Mine Safety Appliances Company • P. O. Box 426 • Pittsburgh, PA 15230

November 13, 2002

Reference: CBRN APR Standard

MSA offers the following comments to the proposed NIOSH Certification Standard for Full Facepiece APR CBRN (September 16, 2002 Draft) per Federal Register Notice September 27, 2002 (Vol. 67, Number 188, page 61108).

1.0 Standard thread connector

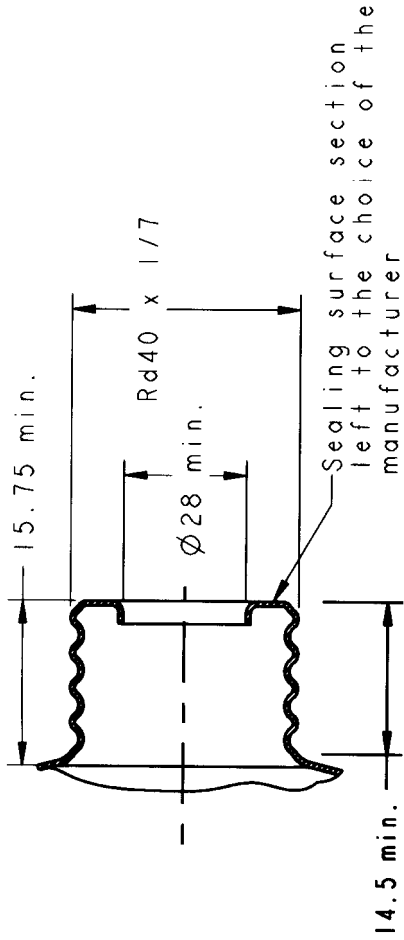
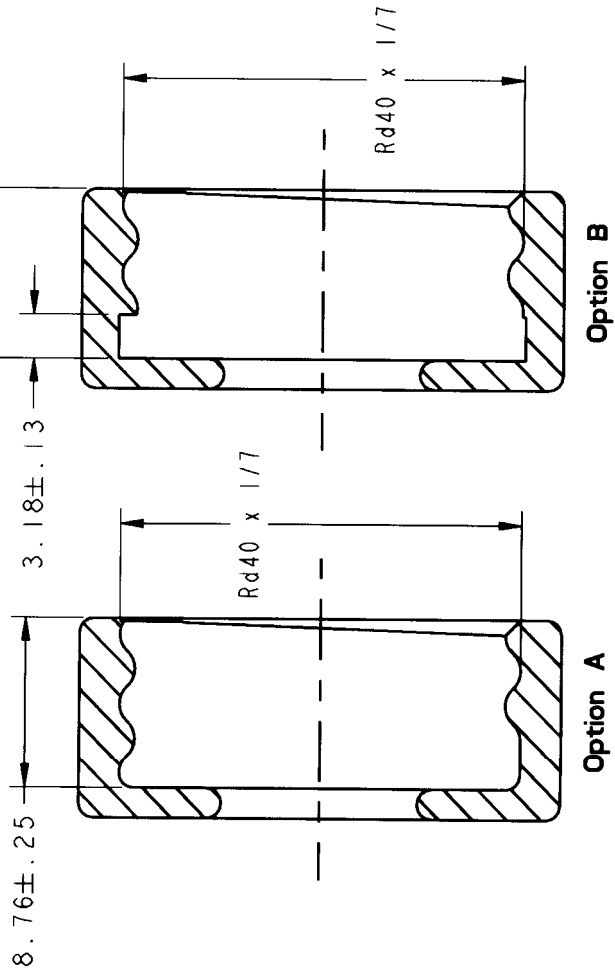
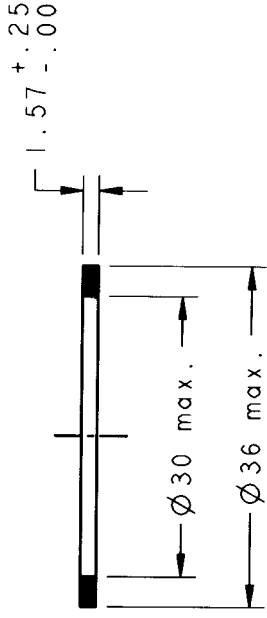
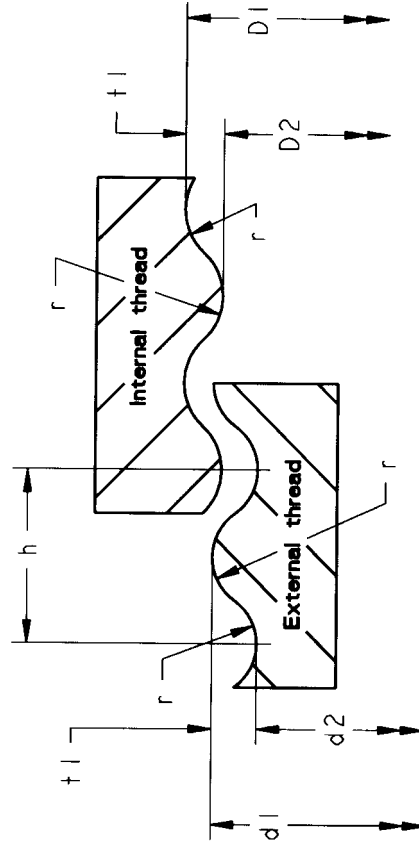
### 4.3.1 and 4.3.2 Thread and Gasket Specifications

The proposed standard (September 16, 2002 Draft) establishes an international specification EN 148-1 for the internal and external thread. However, the proposed standard also specifies Sealing Gasket parameters that differ from those listed in EN 148-1. The result is that we will have a specification for a combination of components, which has no practical field experience. In addition, NIOSH has no way of addressing any changes that could be made by the European Community to the thread specification, yet includes it in their standard.

The internal facepiece thread, external filter thread and sealing gasket specified per the MCU-2A/P Prime Item Specification 55799-MS-200 is a proven, lab and field tested, interface system. Millions of military masks, made with thread forms in accordance with 55799-MS-200 or similar specifications, have been successfully deployed over several decades. With the requirements in the proposed standard (September 16, 2002 Draft), those facepieces could not be used with a CBRN Canister even in an emergency. 55799-

MS-200 and EN 148-1 specify the same rolled thread form Rd40 x 1/7, but different thread length, and gasket.

The shorter thread depth of the military specification was designed to provide a lower profile mask, minimize the possibility of cross-threading a canister in an emergency situation, and reduce potential exposure if the canister would need to be changed in a contaminated environment. The thread and gasket configuration per 55799-MS-200 is compatible with filters that have an external thread per EN 148-1 in addition to military threaded filters such as the C2A1 canister.

*We recommend that NIOSH not reference independent military or international documents in the CBRN Full Facepiece APR standard for the thread and gasket. Instead, we recommend that NIOSH provide detailed designs of the allowable connection configurations, thread and gasket specifications, in the CBRN Full Facepiece APR standard. This will assure compatibility of connections in the field.*

*We recommend that NIOSH maintain the proven thread and gasket systems and allow alternate connection configurations for the facepiece based on (a) Military Specification 55799-MS-200 and (b) EN 148.1 for the facepiece. We further recommend that NIOSH not allow unproven internal thread and gasket designs. Specifying a wider tolerance for the internal thread length of the connector is not recommended because the gasket dimensions need to be adjusted to permit sufficient thread engagement. Information similar to that shown in attachment A should be included in the standard to further clarify the allowable thread and gasket configuration. In addition to the thread and gasket detail, specifications for go and no-go thread and plug gages should be identified to minimize variations between these components.*

*MSA recommends that NIOSH avoid allowing alternate gasket material based only on permeation and penetration characteristics. Additional material properties such as permanent set, modulus, and tear strength must be considered. MSA recommends that the gasket material be EPDM as currently used in gas masks and called out in the concept draft.*
